SERVICE BULLETIN

REFERENCE AUDIO
NUMBER 003
DATE 02-12-88
MODEL AE

1988 COROLLA COUPE REAR SPEAKER STATIC

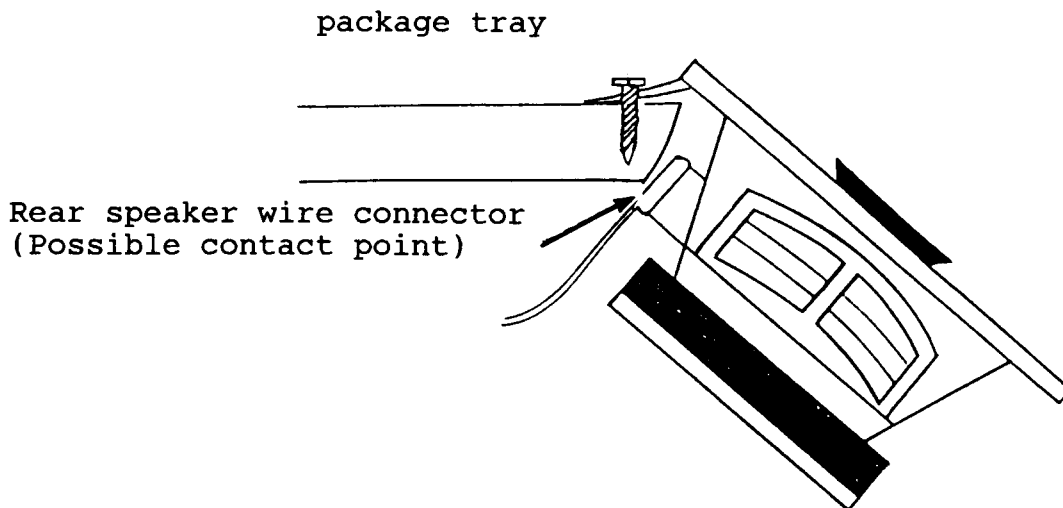
CONDITION: Rear speaker static during idle and downshift operation of vehicle.

CAUSE: Rear speaker wire connectors may contact rear package tray shelf assembly during idle and downshift.

CORRECTION: Relocate speaker wire connectors by bending connectors away from the package tray and insulate the wire connectors.
